# Report / Decision on Change or Cancellation of Condition(s)

s127 application number:	RMA/2023/1314/B
Original application number:	RMA/2023/1314
Applicant:	Sovereign Palms Limited
Site address:	47 Hawkins Road and 7 Selkirk Place, Marshland
Legal description:	Lots 4000 and 4001 DP 606190
Zone:	Residential New Neighbourhood
Overlays and map notations:	Liquefaction Management Area
Road classification:	Local roads (both Hawkins Road and Selkirk Place)
Activity status:	Discretionary activity

Description of application: Change of conditions pursuant to section 127

Figure 2 Amended plan from RMA/2023/1314/B, showing reduced lot sizes from stage 8

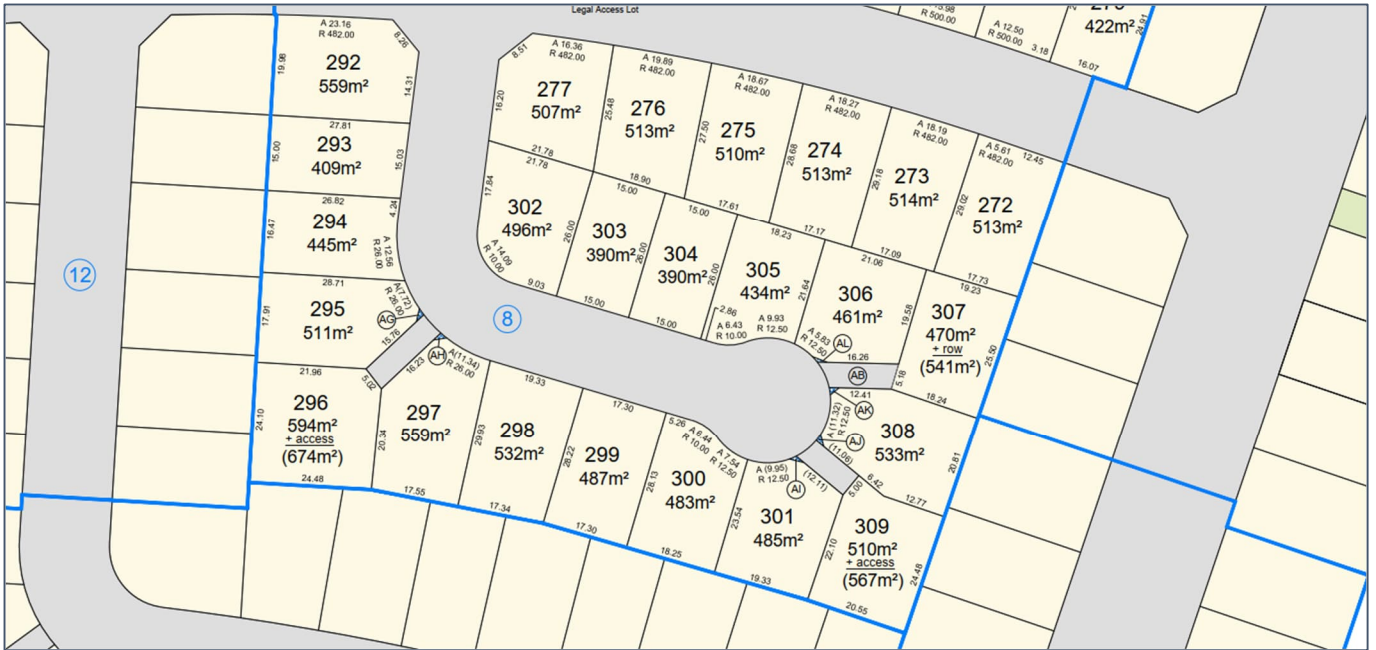
- Increase the number of allotments by seven lots. The net site area for several lots has been amended and, in some cases, reduced (ranging from 300m<sup>2</sup> to 800m<sup>2</sup> and compliant with minimum net site area requirements, not introducing any new non-compliances);
- Changes to staging boundaries and access layouts. The amended layout has some access lots added and others removed within Stage 9, resulting in changes to access lot numbering. Amended access lots comply with relevant transport standards;
- Splitting stage 10 in two (10a and 10b);
- Amending the condition of consent relating to a herpetologist site survey;
- Removing the geotechnical condition for Lot 410 requiring deep geotechnical investigation; and
- Road frontage upgrade works moved from Stage 13 to Stage 7a.

Changes are summarised in table 1 of the application document. Changes to allotments are shown in Figures 1-4, other changes result from some lots being squeezed, resulting in additional allotments in other stages.

Figure 4 Amended plan from RMA/2023/1314/B, showing reduced lot sizes, additional access lots and lots in stage 9

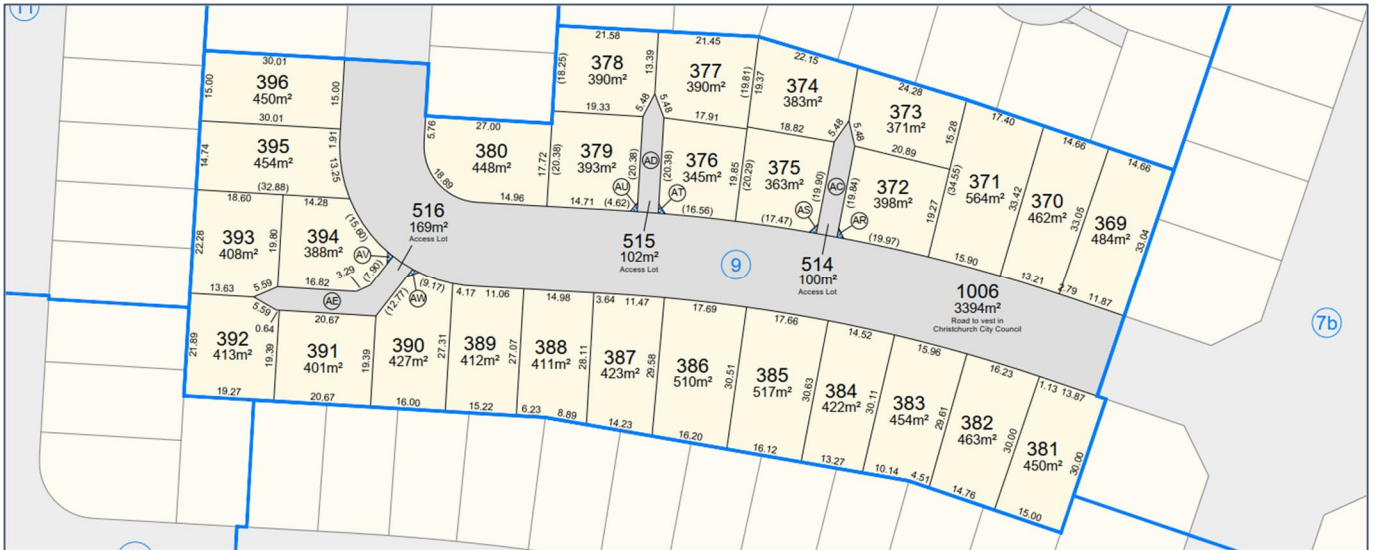
The amended plans increase the number of allotments and change their layout (as shown in Figures 1-4 above) but these changes do not introduce any new non-compliances related to the allotments. I consider this would have a less than minor adverse effect on the wider environment and any persons, as there would be a small change in the lot numbers and no non-compliant lots would result.
